4 DELTA 4 - SPRAB COMMENTS - 11/22/19
2 DELTA 2 - SPRAB COMMENTS - 09/09/19

PIERRE DELRAY I - SPRAB SITE PLAN APPLICATION

A0

BIKE RACK
COMMENT #30

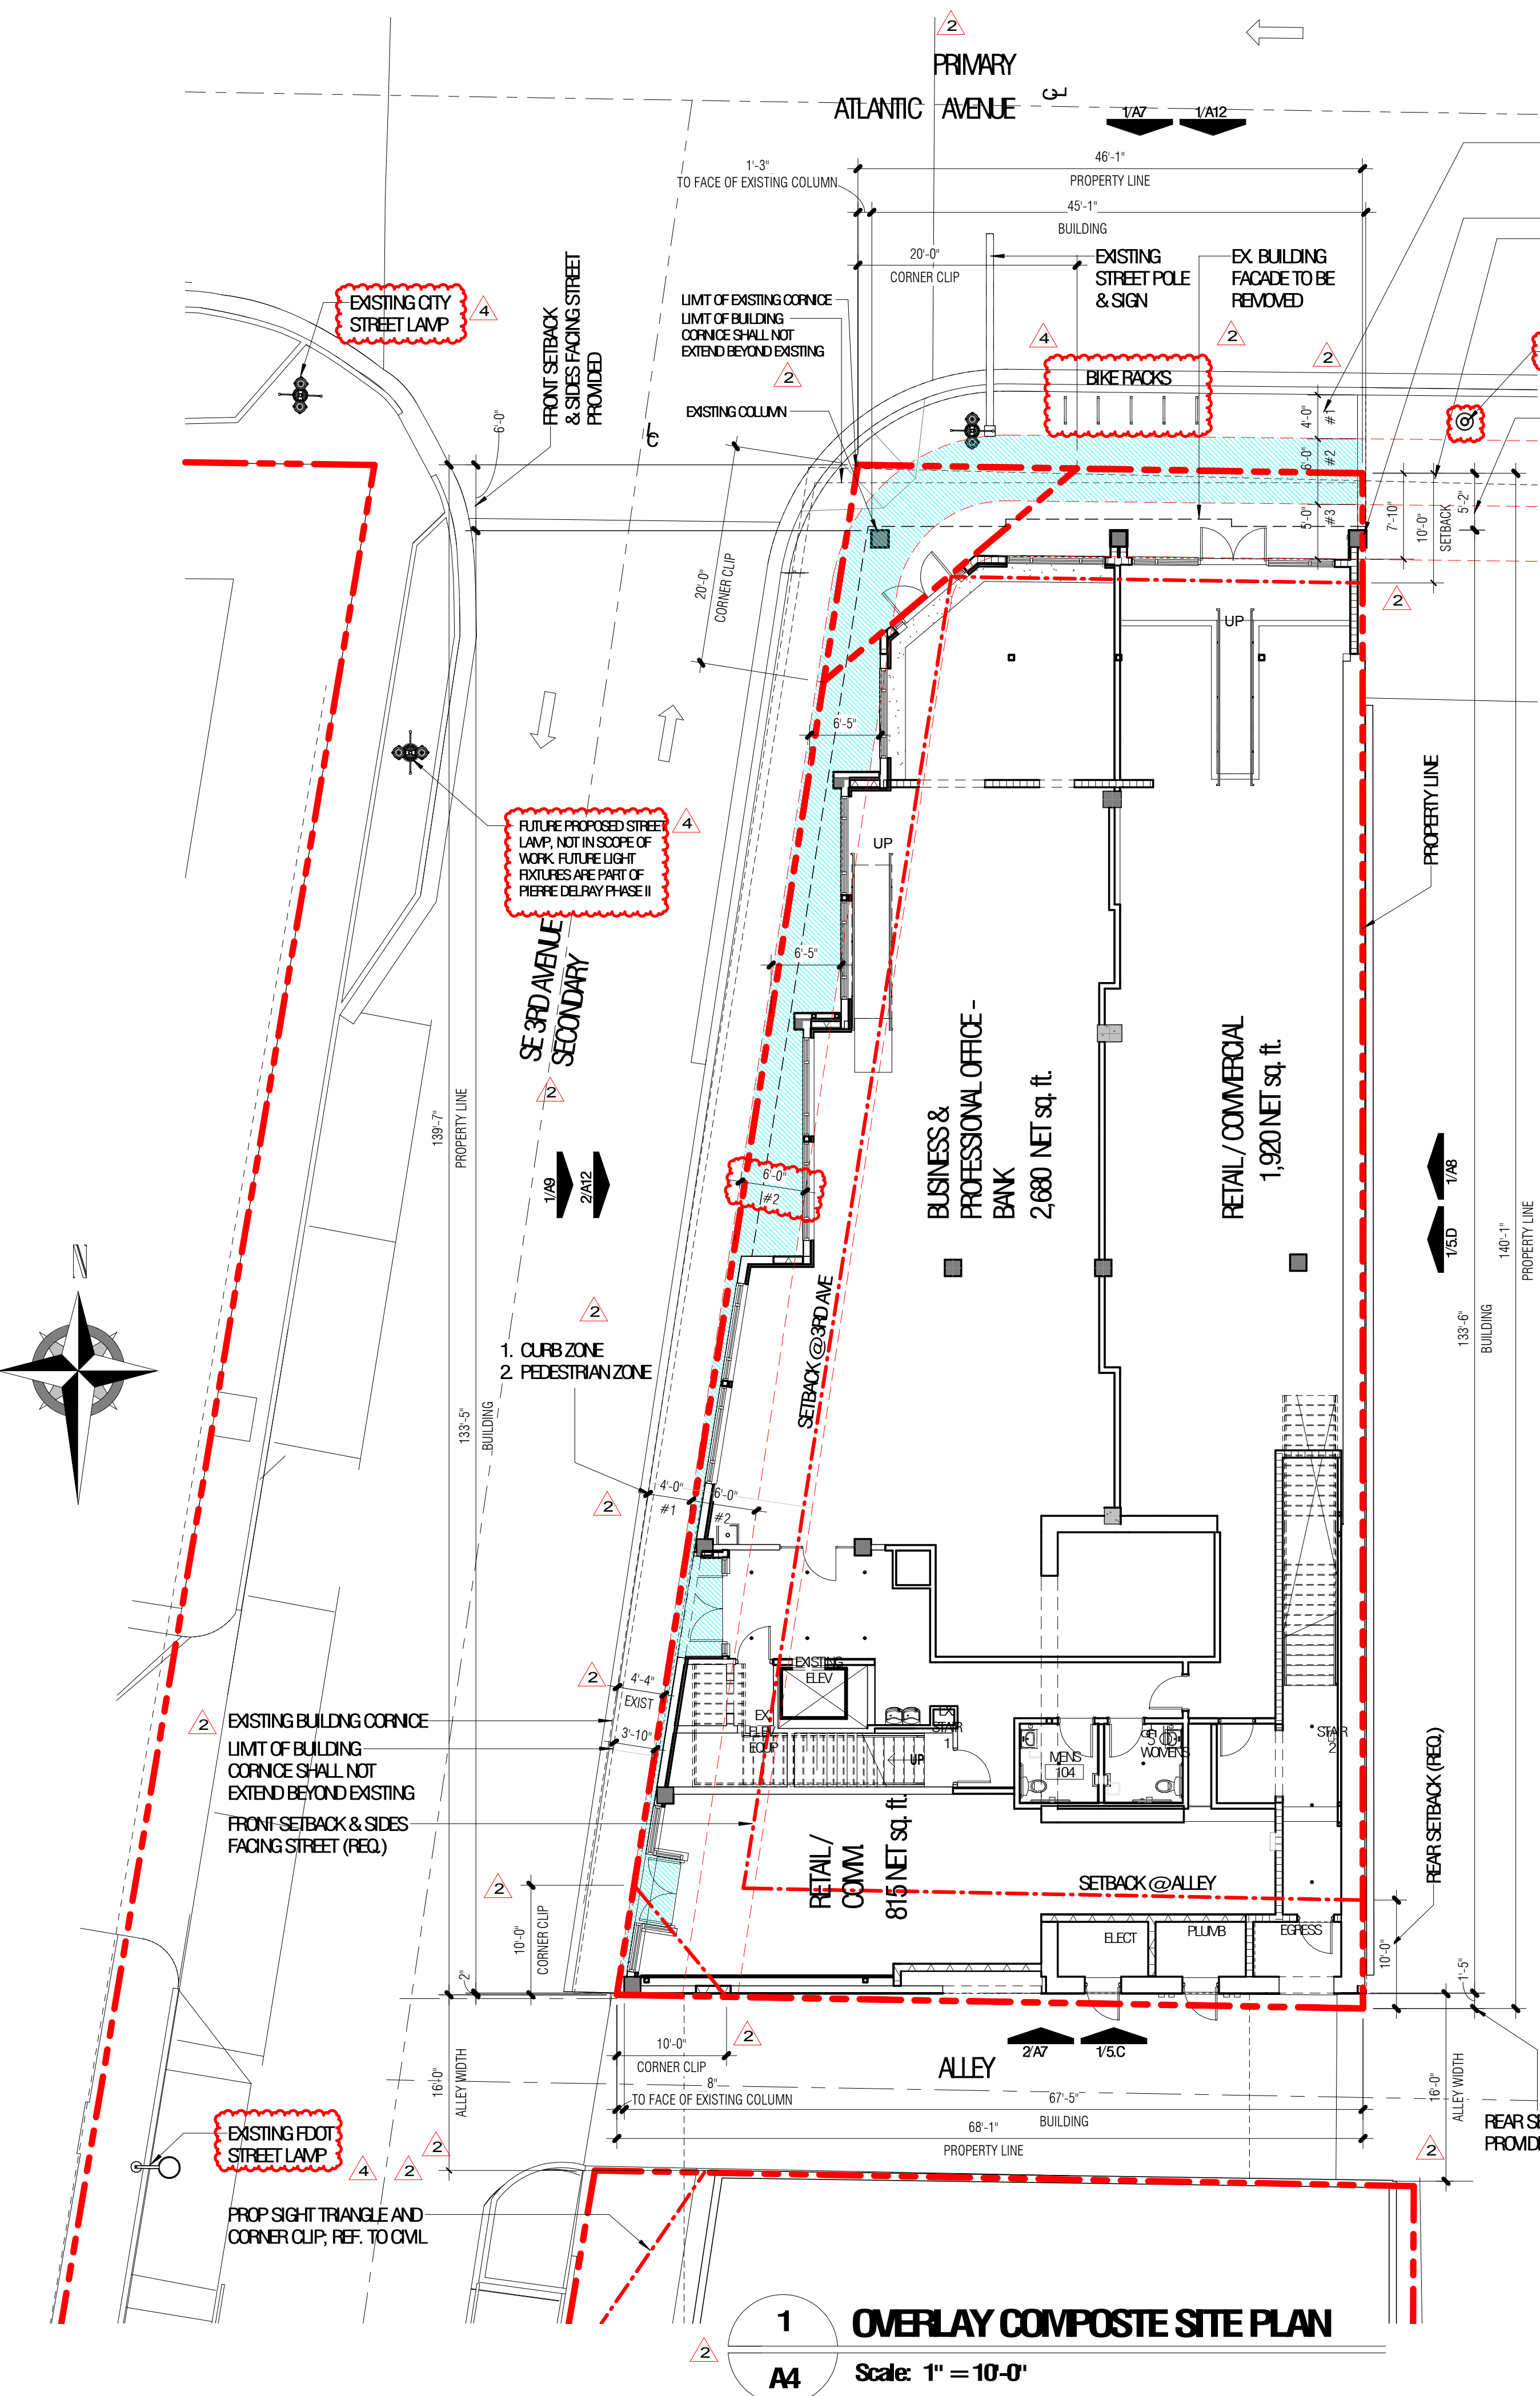
Pursuant to LDR Section 4.4.13(4)(f), Table 4.4.13 (M), Bicycle Parking Requirement, the minimum number of bicycle parking spaces for retail uses are 1 space per 1,000 sq. ft. and for Professional Offices 1 space per 2,000 sq. ft. The proposed building is 14,357 sq. ft. The gross square footage is composed of 2,771 sq. ft. of retail space, and 11,586 sq. ft. of business office space. As such, the retail square footage requires 3 spaces (2,771 sq. ft./1,000 sq. ft.), and the business office square footage requires 6 spaces (11,586 sq. ft./2,000 sq. ft.). As a result, the project is required to provide 9 bicycle parking spaces. These provide bicycle parking racks that can accommodate 9 bicycles. You can put the bicycle rack in the curb zone, but the racks have to be perpendicular to Atlantic Avenue so that the bicycles do not stick out into the pedestrian clear zone.

5 BIKE RACKS ARE PROVIDED TO PROVIDE A TOTAL OF 10 BICYCLE SPACES. RACKS ARE PERPENDICULAR TO STREET.

OPENINGS - CITY OF DELRAY BEACH - LDR - CBD
COMMENT #30

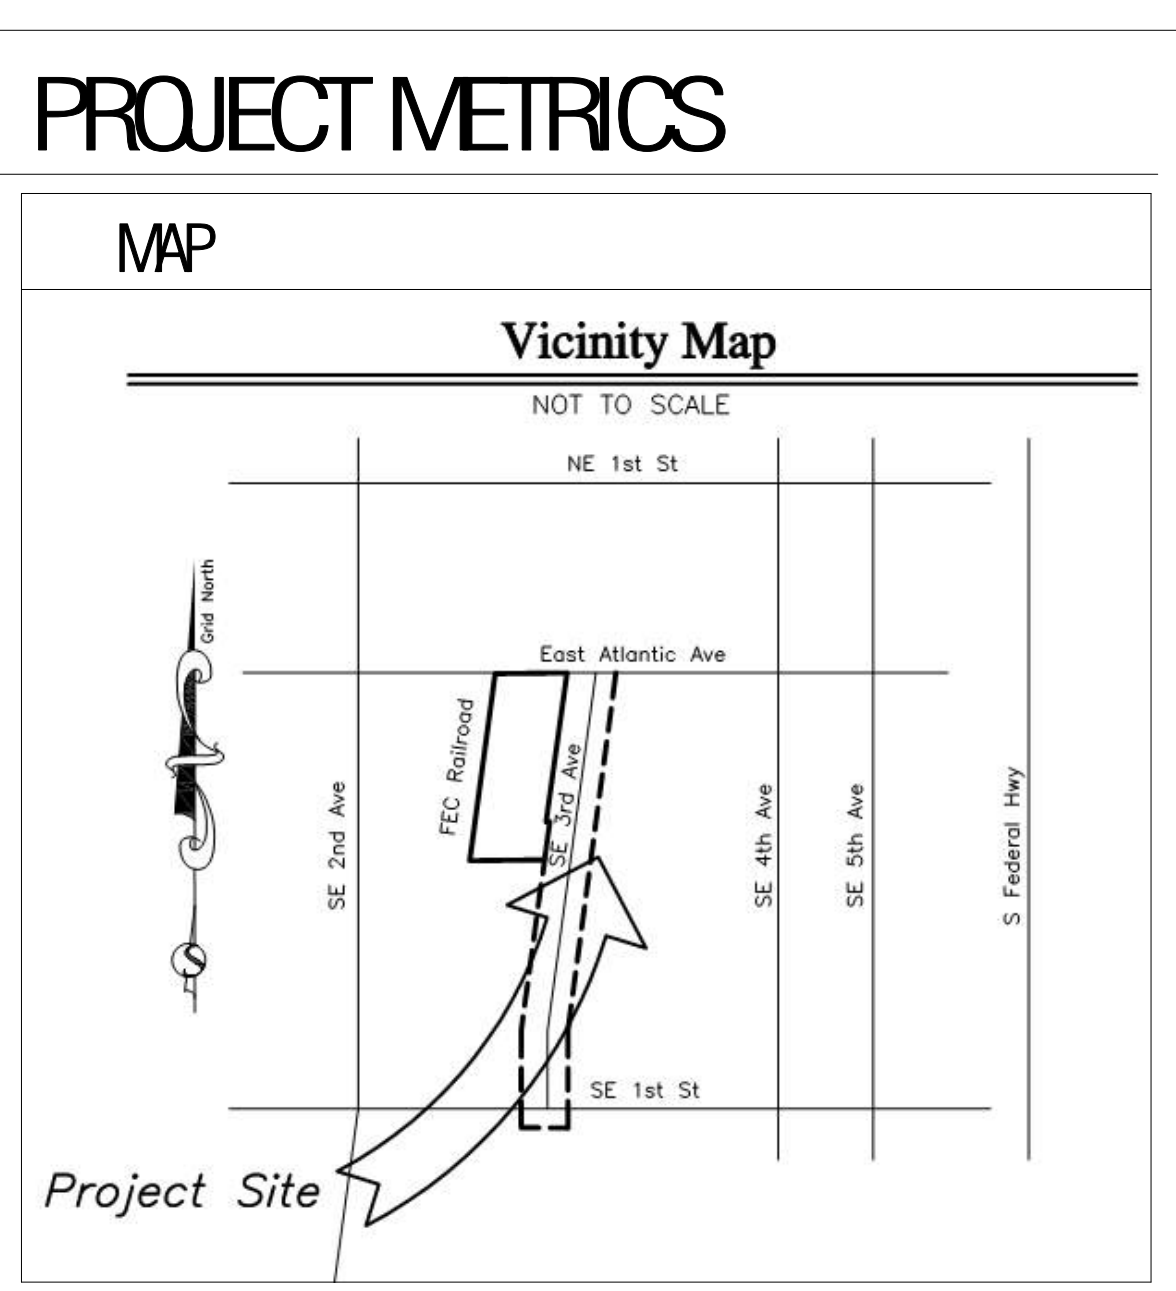
SEC. 4.4.13(F)(9)(a)
(9) Openings. [Amrd. Ord. 28-15 12/09/15] (a) Building facades facing streets or civic open spaces must have transparent windows covering between 20 percent and 75 percent of the wall area of each story as measured between finished floors. Transparent means non-solar, non-mirrored glass with a light transmission reduction of no more than 20 percent. [Amrd. Ord. 28-15 12/09/15]
SEC. 4.4.13(B)(4)(e)
